POST/HAZELTINE ASSOCIATES

1.0 INTRODUCTION AND REGULATORY FRAMEWORK

The Santa Barbara Museum of Natural History's proposed Master Plan project was the focus of a Phase 2 Historic Structures/Sites Report prepared by Post/Hazeltine Associates in April of 2014. The Phase 2 report was reviewed and accepted by the City of Santa Barbara Historic Landmarks Commission (HLC) in 2014. Conceptual plans for the Phase 1 component of the Museum's approved Master Plan were reviewed by Post/Hazeltine Associates in a letter report dated January 14, 2016 that was included in the package of material that accompanied the revised plan set reviewed by the HLC on January 27, 2016. This Letter Report Addendum evaluates revised final plans for Phase 1 of the Santa Barbara Museum of Natural History Master Plan (see Appendix A for plans).

2.0 EXECUTIVE SUMMARY AND PROJECT DESCRIPTION

Site Plan for Proposed Butterfly Garden Exhibit (Sheet A2.20)

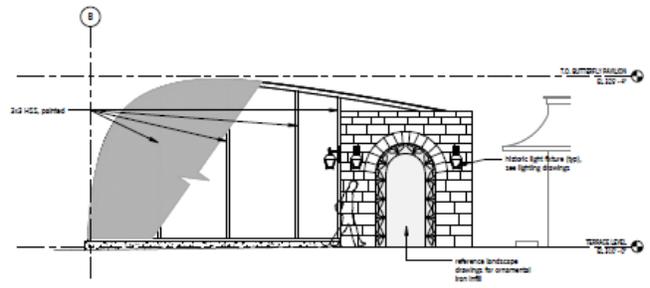
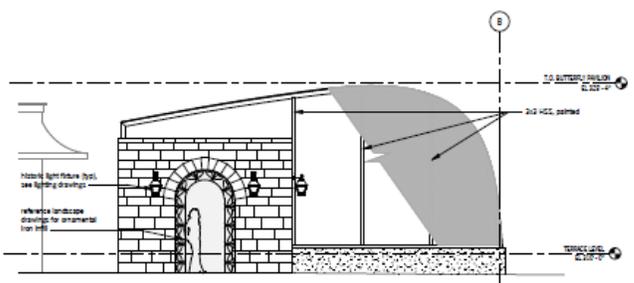
The revised design for the Butterfly Exhibit Garden would be 111 feet $\frac{3}{4}$ -inches long, 34 feet, 10-inches wide; the height varies from at the east end to at the west end. The grade slopes down east to west at 2 percent but the top elevation of the Butterfly Garden Exhibit remains constant. The height of the vestibules has been raised 16 inches (two cmu courses) to address comments from the HLC regarding their proportions in relation to the arched openings. It would feature rectangular vestibules with cmu walls whose exteriors would be clad in 2-inch thick rectangular rusticated sandstone veneer mimicking the appearance of sandstone blocks. The horizontal coursing of the sandstone would be graduated with the largest blocks at the base of the walls. Arched openings, 9-foot, 3 $\frac{1}{2}$ inches in height, would be set on the east, west and south sides of the vestibules. The arched openings' surrounds would be clad in 2-inch thick sandstone veneer emulating the appearance of voussoirs centered on a wedge-shaped keystone. The openings would be covered with metal gates embellished with butterflies and motifs inspired by the existing wrought iron gates at the main entrance to the Museum's 1922 building. The interior of the vestibules would be stucco-clad with an ornamental border of sandstone defining the edge of the openings. A cmu wall linking the two vestibules would form the rear wall of the exhibit space; the wall varies in height from 6 feet, 2 inches to 7 feet, 11 inches at grade slopes from east to west. Its south side, which would face into the exhibit space, would be clad in sandstone veneer while the north side of the wall facing the Collections and Research Center would be sheathed in stucco. A coping course of sloped sandstone veneer would cap the vestibules and the sandstone-clad wall forming the north side of the exhibit space.

The proposed Butterfly Garden Exhibit would be located off the south elevation of the Collections and Research Center and slightly southeast of the Gladwin Planetarium from which it is separated by a gated sandstone wall that is less than 30 years of age. The Phase 1 HSSR determined that the buildings located adjacent to the proposed exhibit including the Collections and Research Center and the Gladwin Planetarium are not significant historic resources for the purposes of environmental review. Consequently, while the proposed Butterfly Garden Exhibit would abut the Collections and Research Center building and be in close proximity to the planetarium this would not impact views towards a significant historic resource or elements of the surrounding cultural landscape including Mission Creek which is located south of the proposed location of the Butterfly Garden Exhibit because it is built over what was an asphalt-paved parking area. The exhibit space would be set a sufficient distance from MacVeagh house and cottage, which are located to the west, to preclude substantial impacts to the setting of these buildings. Moreover, the construction of the permanent Butterfly Garden Exhibit would remove the existing asphalt-paved parking area that is currently the site of the temporary butterfly exhibit and replace it with garden-like exhibit space and naturalistic landscaping which would enhance the setting of the creek's riparian corridor. Therefore, the placement of the proposed Butterfly Garden Exhibit would not result in significant impacts to significant historic resources or the cultural landscape.

The revised design for the Buttery Garden Exhibit allows the exhibit to meet its programmatic requirements while providing a more nuanced transition between the Museum's built environment and the natural setting of Mission Creek by reducing the asymmetry of the exhibit's massing while maintaining a sense of openness on the creekside elevation and detailing the vestibules, which would feature sandstone cladding arched openings and Spanish Colonial Revival style lighting to emulate traditional stone masonry of early 20th century Santa Barbara. From the perspective of the Secretary of the Interior's Standards for Rehabilitation, detailing the structure to meld natural materials such as sandstone with steel for the support system and mesh covering is supportable since the proposed exhibit is not in close proximity to significant historic buildings, structures or features. Moreover, de-materializing the structure through the use of natural materials, a steel armature painted light gray and the steel mesh covering to accentuate the structure's transparency helps minimize its visual impact on the riparian corridor along the north bank of Mission Creek and the surrounding cultural landscape. Therefore, the revised design for the Butterfly Garden Exhibit, which would not directly or indirectly impact the significant historic resources identified in the 2011 Phase 1 Historic Structures/Sites Report or the 2014 Phase 2 Historic Structures/Sites Report, meets Standard 9. The proposed revisions also meet Standard 10 since the Butterfly Garden Exhibit could be removed in the future without substantially impact to significant historic resources or the surrounding significant cultural landscape.

Elevations for Proposed Butterfly Garden Exhibit (Sheet A2.30)

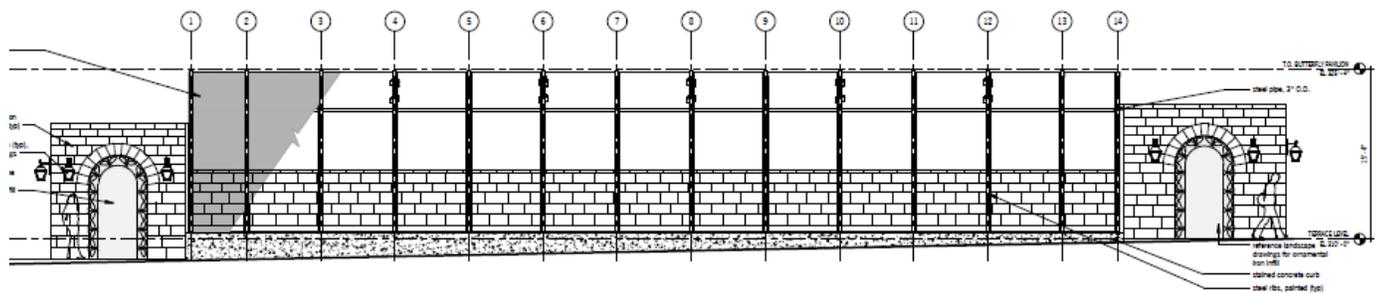
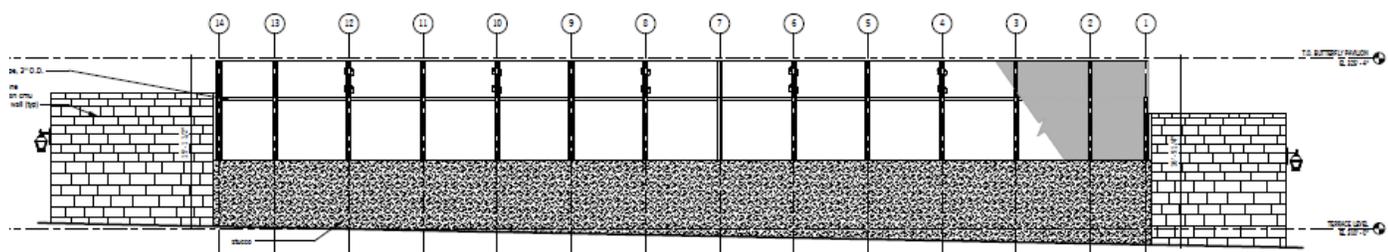
The design of the vestibules and coursing of the sandstone veneer has been revised to feature regular horizontal courses emulating the appearance of a late 19th or early 20th century stone wall. The veneer would be composed of 2-inch thick rectangular stones, with the coping detail, the arches' voussoirs and keystones mortar joints designed and detailed in a traditional manner. The height of the vestibule's walls has been increased by 16 inches to add massing above the arches; this gives the vestibules' the proportions

The revised scheme for the gates would feature a 6-foot, 8-inch gate set in a 9-foot, 2-inch fixed metal grille. The operable gate would be 6-foot, 8-inches tall, by 3-foot, $\frac{3}{4}$ inches in width. The fixed grille work would feature stylized butterflies surrounding a centrally-placed semicircular element whose design motifs are inspired by the entrance gate on the Museum's 1922 building. The rectangular gate would feature scrollwork along its sides and base surrounding a series of vertical pickets centered on a symmetrically placed scrollwork motif. With the exception of the butterfly motif the gates decorative detailing is inspired by the wrought iron gate at the main entrance to the 1922 building. The gates' decorative detailing would feature a centrally-placed fan element and a border of stylized butterflies (Landscape Sheet L1.3 & A2.40).

The design of the Butterfly Garden Exhibit has been revised to feature a balanced arrangement of 5-inch metal supports covered by mesh which is more architectural in character than the scheme reviewed in 2014. The metal supports would be painted a light gray color designed to be visually subservient to the stone-clad vestibules and naturalistic landscaping.

Site Plan for Backyard (Sheet L3.4)

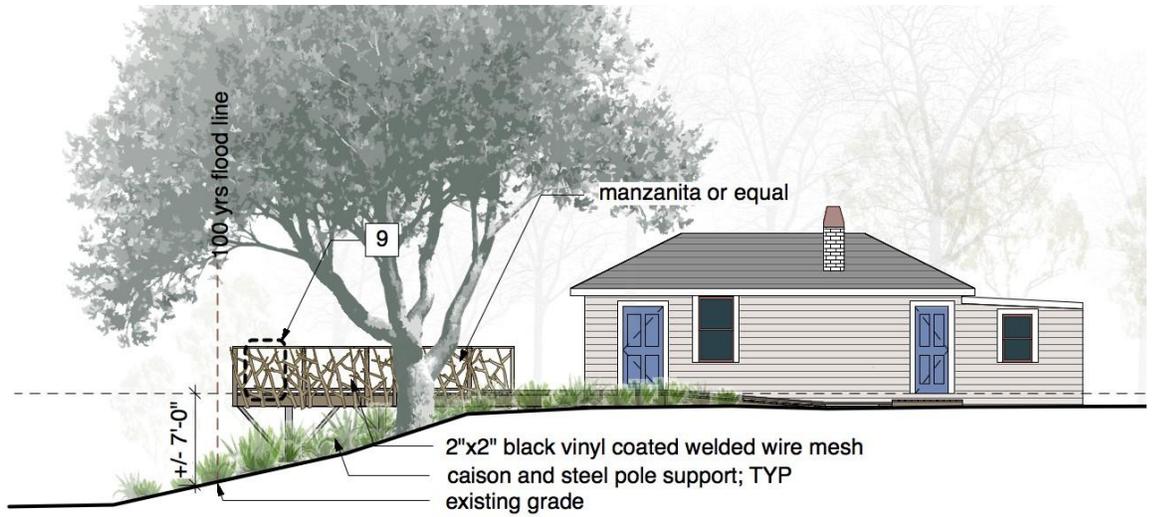
1) Revisions to the design for the proposed ADA-compliant boardwalk to and around the “backyard” (nature play activity areas). The pathway design has been revised to feature circular deck elements at its east and west ends (the deck at the east end would serve as a gathering place for visitors and school groups while the circular deck at the west end of the pathway would serve an overlook providing views of Mission Creek). While the boardwalk would maintain the sinuous configuration of the previous design, it would be composed of faceted rather than curved segments which would conform to the constraints of the Trex decking material, which would be a light gray color (“Gravel Path”). The boardwalk deck would be composed of horizontally set 4-foot by 2-inch Trex recycled composite planks, fire-rated ASTM E84 Class A or B. The boardwalk’s decking would be supported by 2-inch by 4-inch Trex members that would be

The configuration of the pathway and overlook at the west end of the boardwalk has been revised to avoid impacts to a mature tree and to maximize the separation of the boardwalk and overlook from MacVeagh Cottage. A section of the ADA compliant boardwalk linking MacVeagh Cottage to the play area would be defined by tree trunks, boulders and berms, which would be used to confine the engineered mulch surface of this activity area. The surface of the play area would be stabilized with an "egg crate" type material set beneath the engineered mulch layer (Sheet L1.4);

Detail of Overlook, Sheet L1.4)

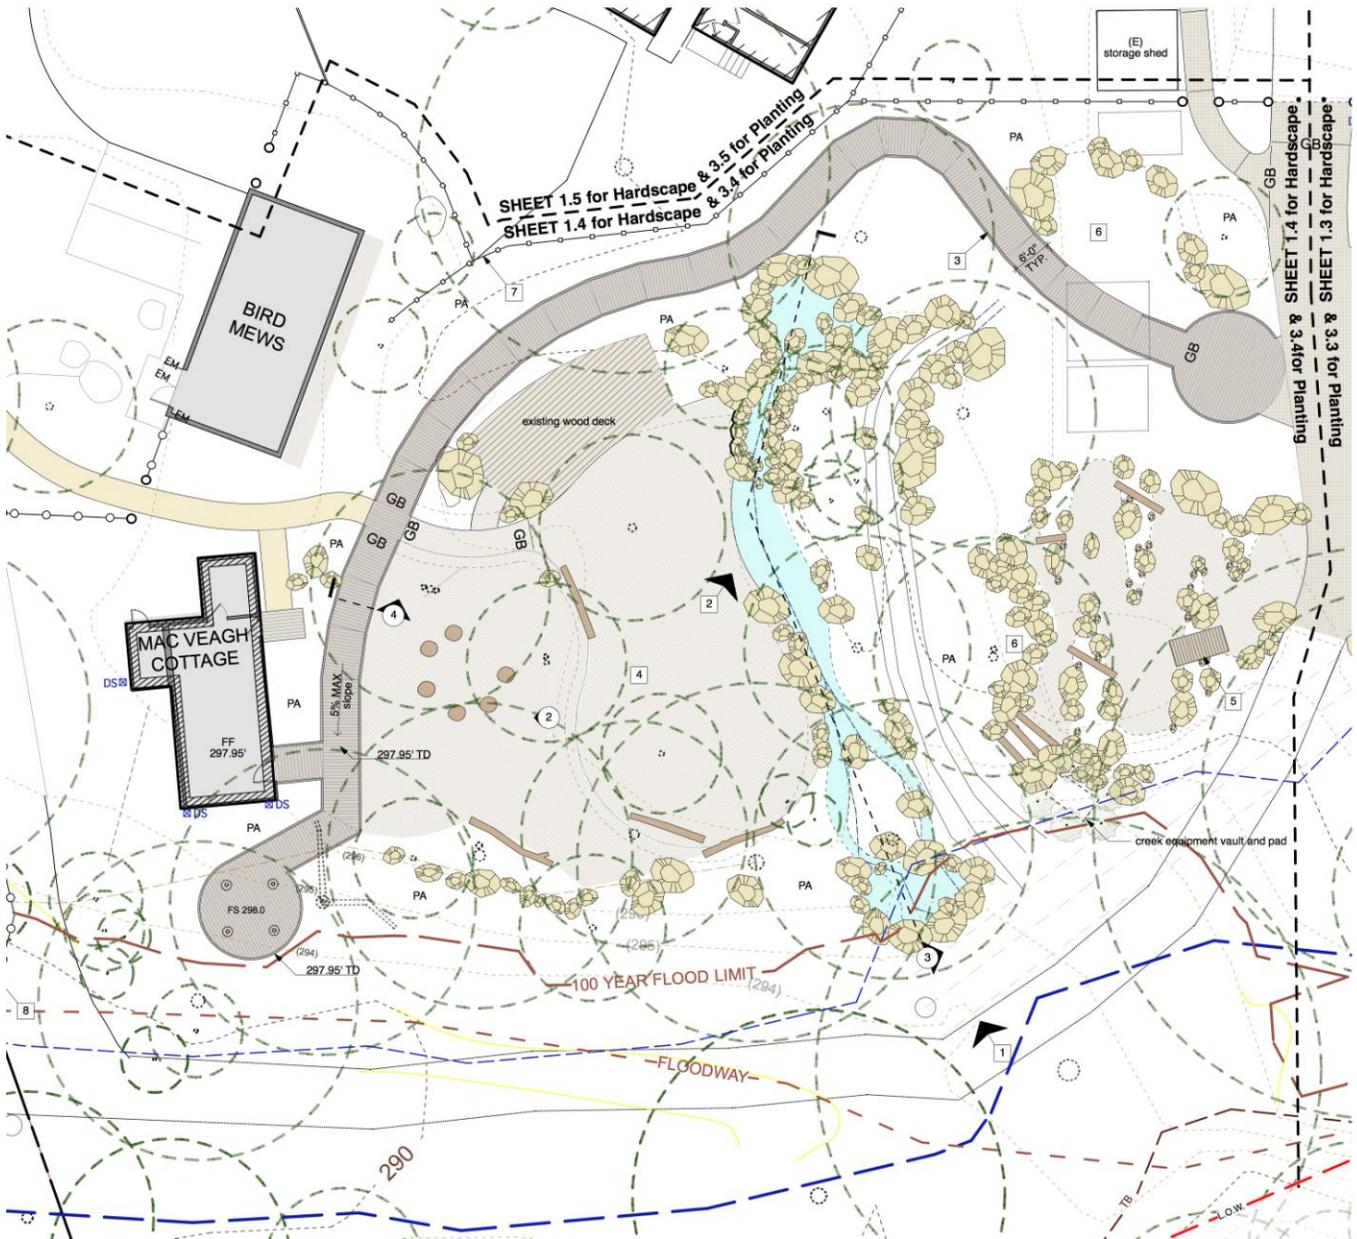
2) Revised scheme for the circular overlook deck at the "backyard" nature clubhouse (MacVeagh Cottage) built of Trex recycled composite lumber, fire-rated ASTM E84 Class A or B with a composite wood post-and-rail style railing which would feature an infill of trimmed Manzanita branches on the exterior side and a 2-inch by 2-inch vinyl coated welded wire mesh on the interior side to meet code requirements. The base of the railing would serve as a skirting detail that would shield the deck supports from view (Sheets L1.4, L3.4, & A1.12). The deck would be supported by a steel framework of 3-inch steel pipes (providing lateral support) that would be set on four, 8-inch vertical pipe style supports supported by four 18-inch diameter concrete caissons that would be set below grade. The caissons would be set back from the edge of the deck and surrounded by native plants to minimize their visibility (Sheet L1.4, details #2 & #9 and Sheet L3.0);

The revised scheme for the overlook would feature a railing composed of fire-rated Trex posts and rails with an infill of Manzanita branches. The interior side of the railing would feature metal screening to meet code requirements. Because this railing with its infill of branches would not read as a traditional architectural element and is physically separated from the historic building, the use of an earth tone hue for the decking and railing color rather than the colors selected for MacVeagh Cottage would be

Proposed Trash Enclosure (Sheet A4.10)

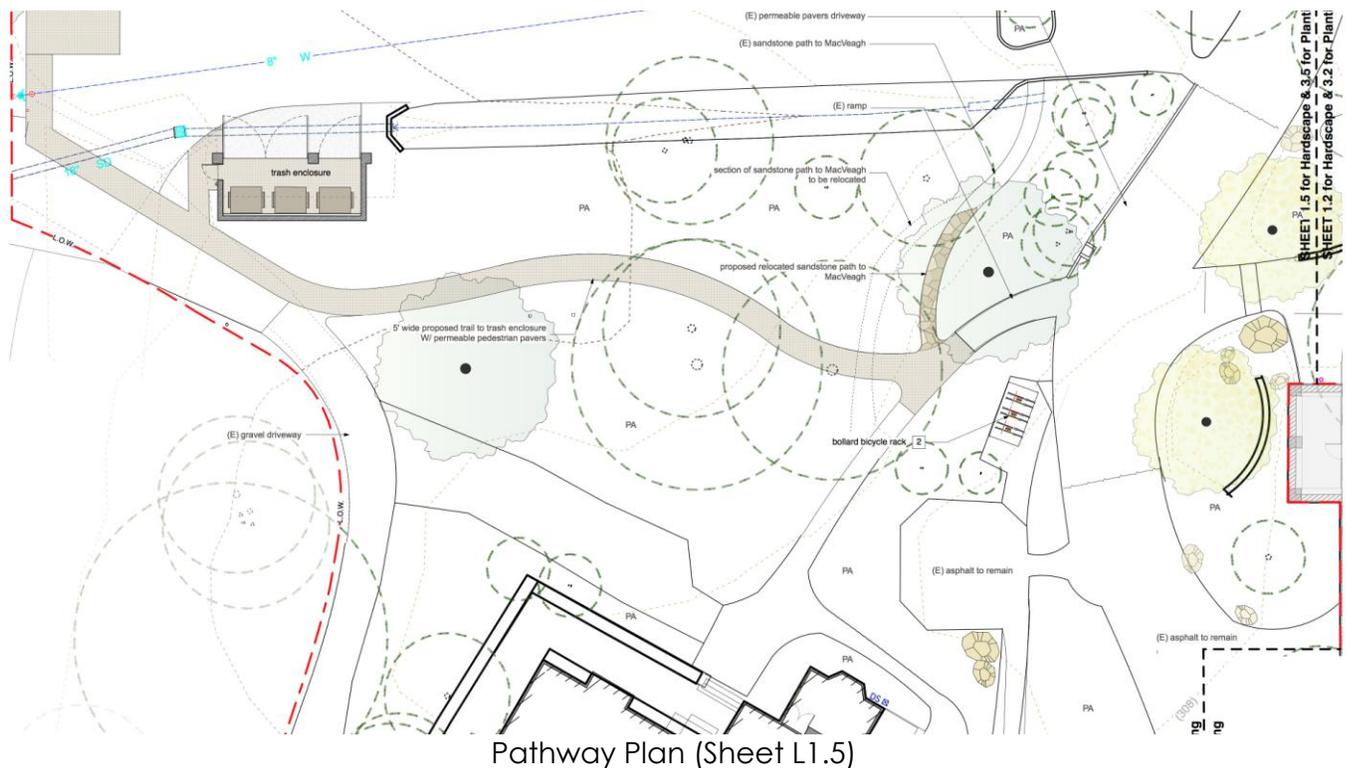
The significant historic resources located in the vicinity of the proposed trash enclosure are MacVeagh House and MacVeagh Cottage and the significant cultural landscape identified in the Phase 1 HSSR. The tree approved for removal is a 14-inch non-native tree. The tree does not appear to be of sufficient trunk size or age to date to the MacVeagh family's occupancy and is therefore, not a historic feature of the property. As currently proposed, the installation of the trash enclosure would not result in a substantial change in use for the area since it abuts the currently paved parking lot. The trash enclosure, which would be 8-foot tall, would not create a significant visual impact since the surrounding landscaping is being enhanced to minimize the visibility of this feature and the enclosure's wood clad gates and man door are of a traditional design and will be painted in a color that melds with the surrounding vegetation.

- *Final plans for the trash enclosure, including material type for the gate and color and dimensions of the planking, shall be submitted to the City's Urban Historian to ensure that the alterations follow the Secretary of the Interior's Standards for the Treatment of Historic Properties.*

Pathway Plan (Sheet L1.5)

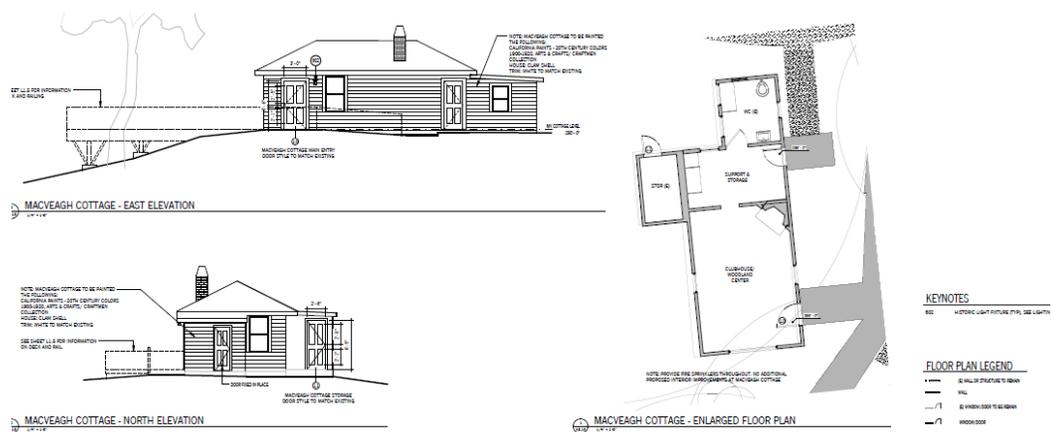
Pathways: While creating a more direct path of travel the new walkway has been designed to emulate the appearance of the naturalistic pathways that currently exist in the area. Consequently, the installation of a new walkway linking the Museum with the west end of the parking lot and trash enclosure would not impair the setting of MacVeagh House or the surrounding cultural landscape, thereby meeting Standard 9. Standard 10 is met because the walkways could be removed in the future with no impact to significant historic resources or contributing elements of the surrounding cultural landscape. Therefore, implementation of the proposed design would result in a less than significant (Class III) impact to significant historic resources.

Alterations to MacVeagh Cottage (Sheet A3.10)

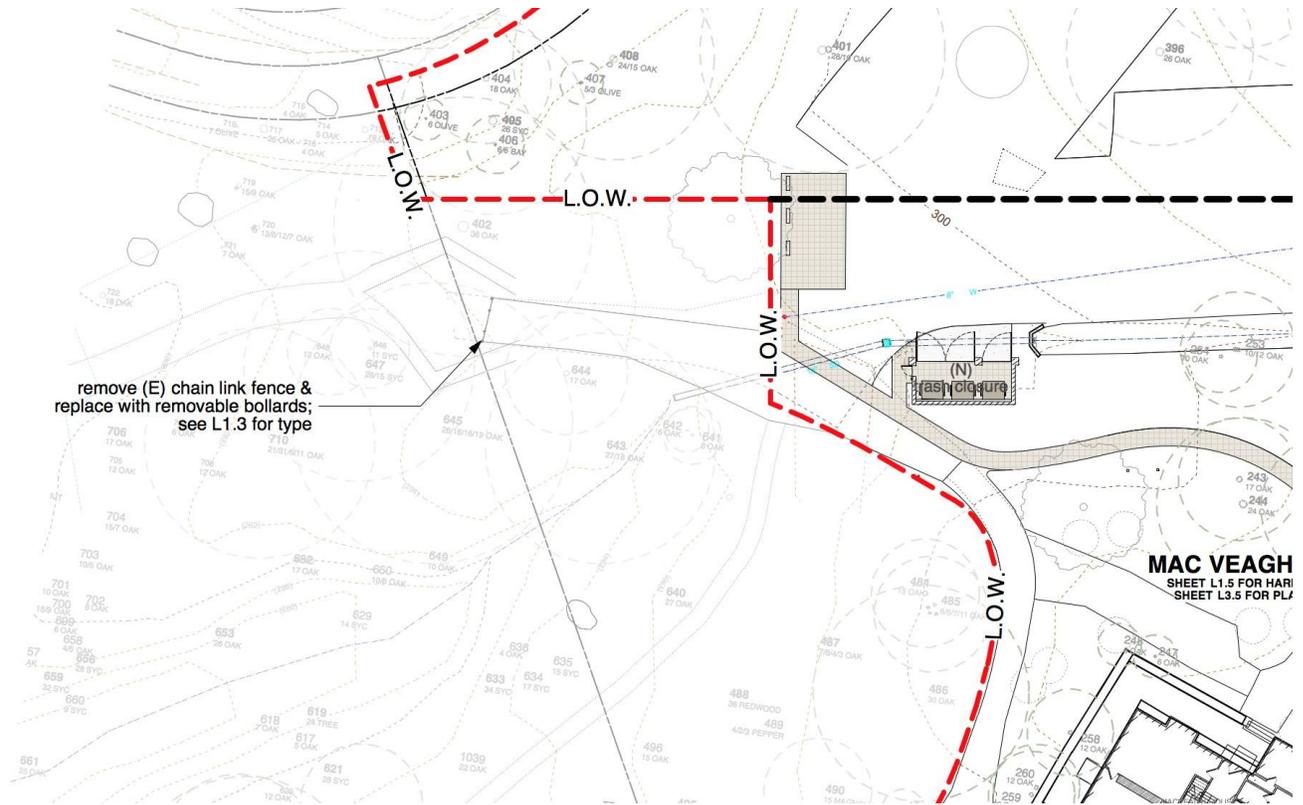
- As noted above under Section 5.7, the proposed railing design meets Standard 9.
- The proposed color scheme for the cottage is sympathetic to the color scheme of the nearby Raptor (Bird) Mews building and MacVeagh House and would blend into the woodland setting. Therefore, the proposed painting scheme meets Standard 9.
- As noted in the previous report, recapitulating the design of the existing door at a larger size to meet universal access requirements meets the intent of the Standards since it would maintain the building's design integrity.

Proposed Plaza (Sheet L1.2)

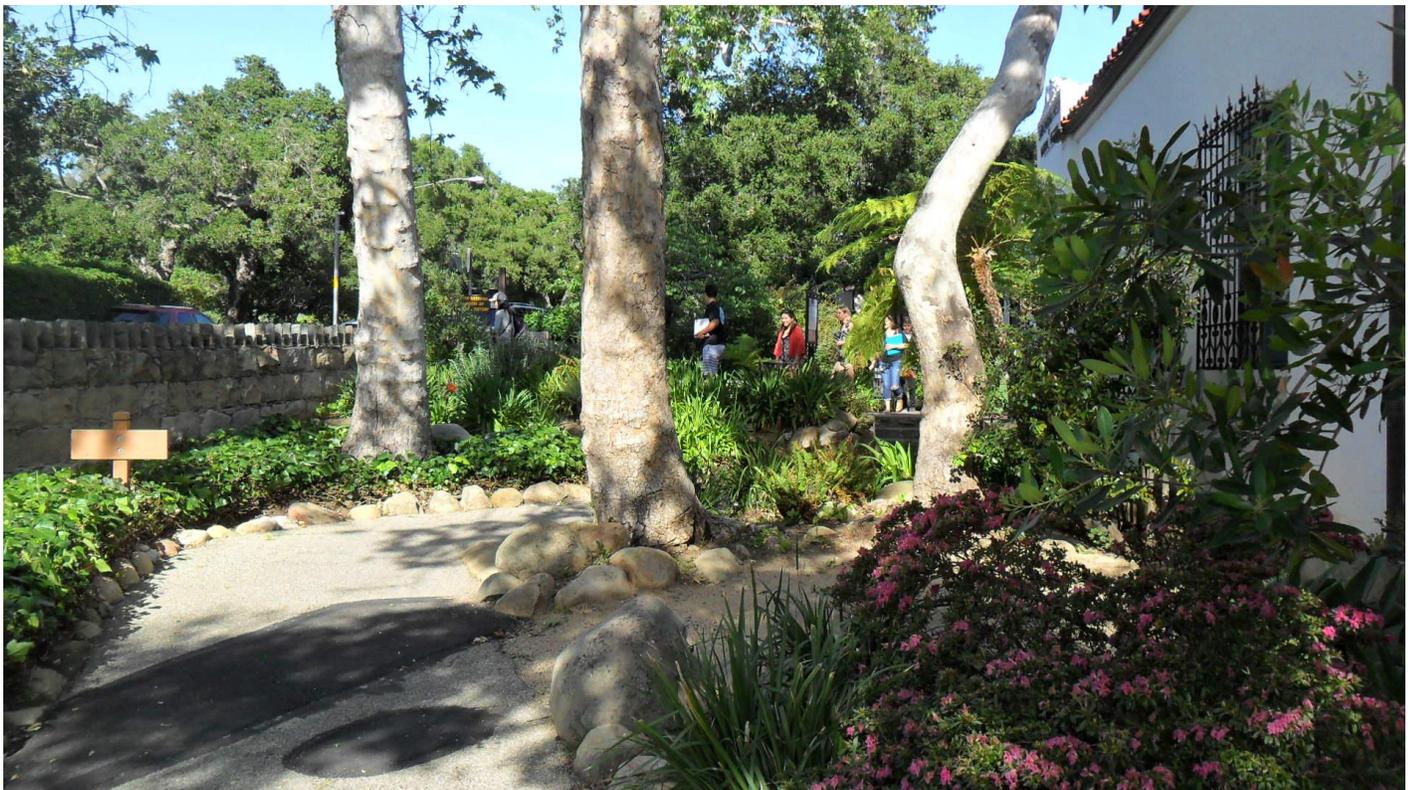
The plaza and Walkway Design: The plan for the walkway and plaza would substitute permeable pavers for the flagstone pavers previously proposed for this area. The substitution was

necessitated by the need to provide a traffic-rated surface for emergency, building maintenance and delivery vehicles that will occasionally park in this area. The proposed scheme, while it employs permeable pavers, has been designed to recall the type of paving schemes sometime found in the Mediterranean architectural tradition. This can be seen in its use of Santa Barbara sandstone for banding elements, the employment of traditional paving patterns such a running bond and herringbone and the color of the buff permeable pavers that are visually sympathetic to that of the Hazard estate walls as well as the extensive series of natural sandstone outcrops found in this part of Mission Canyon. While permeable pavers are a modern material, the Secretary of the Interior's Standards for Rehabilitation do not preclude the use of more contemporary materials provided they are sympathetic in color, design and appearance with the historic setting. Because the plaza and walkway have been designed to recall traditional motifs of Mediterranean style architecture its installation would not impair the setting of the adjacent significant historic resources including the Hazard estate wall and the Museum buildings constructed between 1922 and the late 1930s. Moreover, these improvements could be removed in the future with no impact to significant historic resources. Therefore, the proposed design for the entrance plaza and walkway, meets Standards 9 and 10.
